Jury Report

Carlton United Brewery Site (Balfour Park) Design Excellence Competition

Fig 2.2 Competition Brief

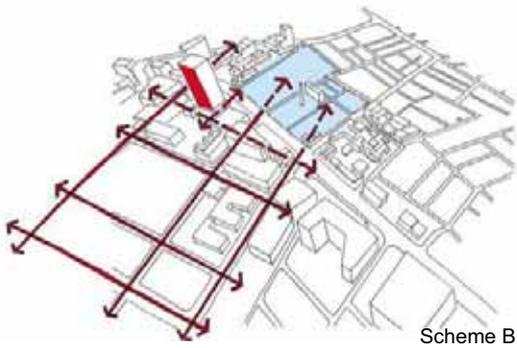
The exploration of multiple towers, positioned within the controls of Fig.2.2 of the Competition Brief, resulted in an unacceptable wall of buildings when seen from many viewpoints, including the important vista from Railway Square and the contextual street view from Balfour Street in Chippendale. The repositioning of one of the towers, as per some of the non-complying schemes, to the Broadway edge, helped alleviate this unforeseen problem and merits serious consideration if increased height in limited locations is desired as a trade off for providing solar protected public open space. Furthermore, the 'twin towers', positioned as per the Competition Brief, and found in a number of the proposals, seemed to not form any meaningful relationship with the UTS Tower. The strong pedestrian desire line from Chippendale to Railway Square (as opposed to Jones Street) was generally ignored, with one exception.
